TECHNICAL BULLETIN
K225NAS2
14 JAN 2015

Service Action: Charge Air Radiator Duct Bolt Torque Relaxation

XF (X250)

**NOTE: this bulletin is reissued with an additional part and updated Service Instruction.**

E162923

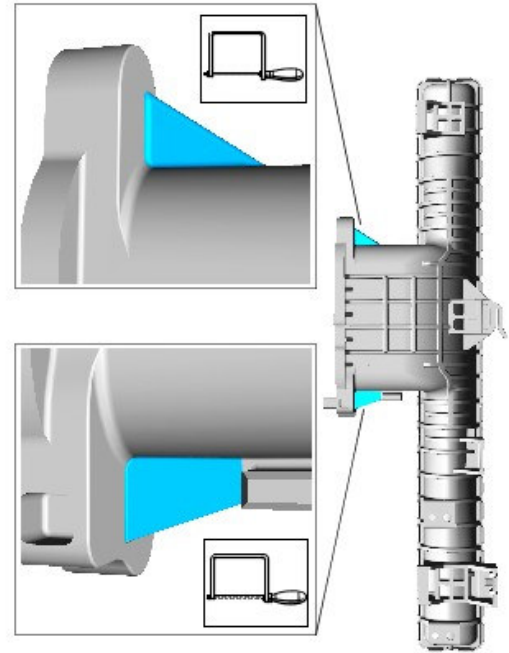
3. Cut out the highlighted sections of the charge air radiator right-hand end tank opening as shown.

E162924

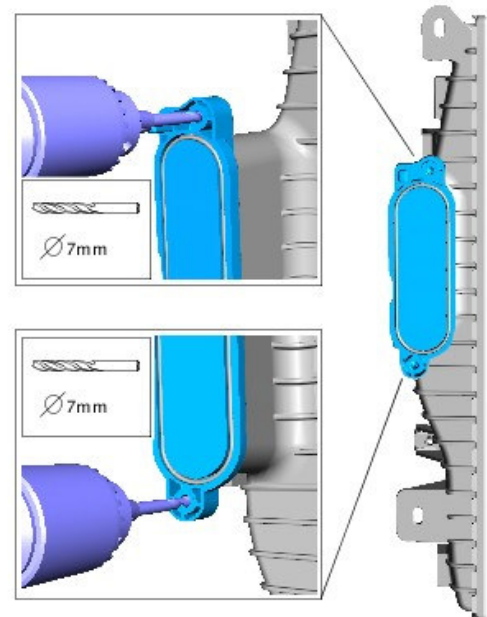
4. Using a 7mm drill bit, drill to a maximum depth of 15mm to go all the way through the charge air radiator left-hand end tank opening's brass inserts and plastic moulding.

E162925

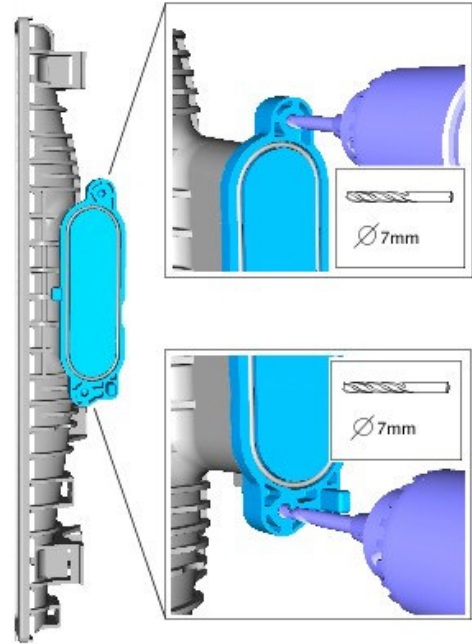
5. Using a 7mm drill bit, drill to a maximum depth of 15mm to go all the way through the charge air radiator right-hand end tank opening's brass inserts and plastic moulding.

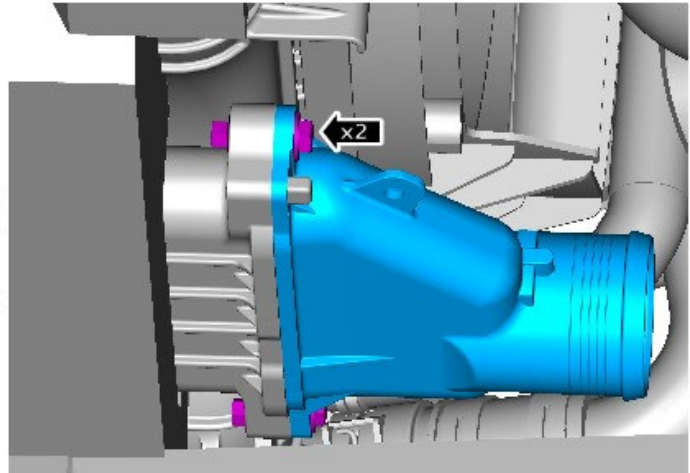
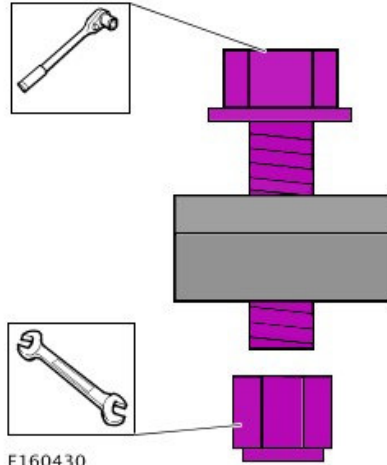
7.  **NOTE:** make sure the rubber sealing gasket between the duct and the charge air radiator is correctly positioned.

duct to the charge air radiator left-hand end tank opening:

- Use the 2 bolts (C2D4727) and the 2 lock nuts (C2P2765) and a suitable 10mm spanner to hold the lock nut
- Torque: $7\text{Nm} \pm 1.1\text{Nm}$.

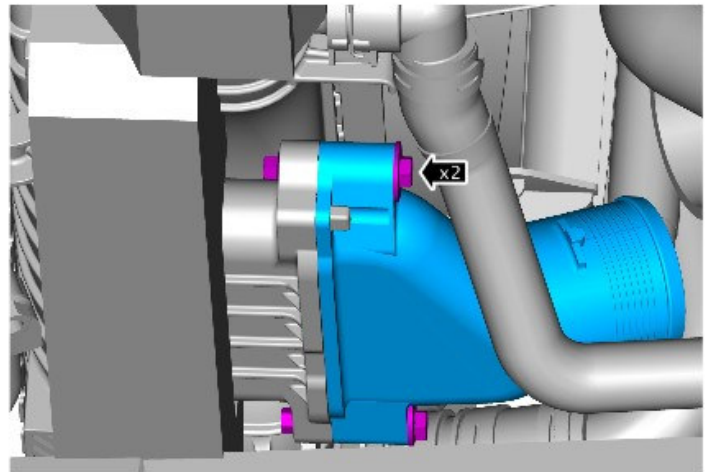
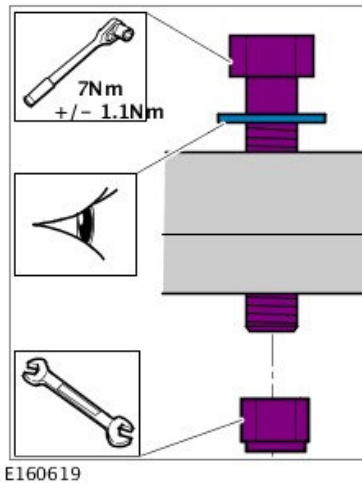
8.  **NOTE:** make sure the rubber sealing gasket between the duct and the charge air radiator is correctly positioned.

-  **NOTE:** make sure the washer is next to the bolt head to prevent any damage to the plastic charge air radiator end tank during the tightening process.

Assemble the duct to the charge air radiator right-hand end tank opening:

- Use the 2 bolts (C2D2734), 2 washers (C2P23515), and 2 lock nuts (C2P2765) and a suitable 10mm spanner to hold the lock nut.
- Torque: $7\text{Nm} \pm 1.1\text{Nm}$.
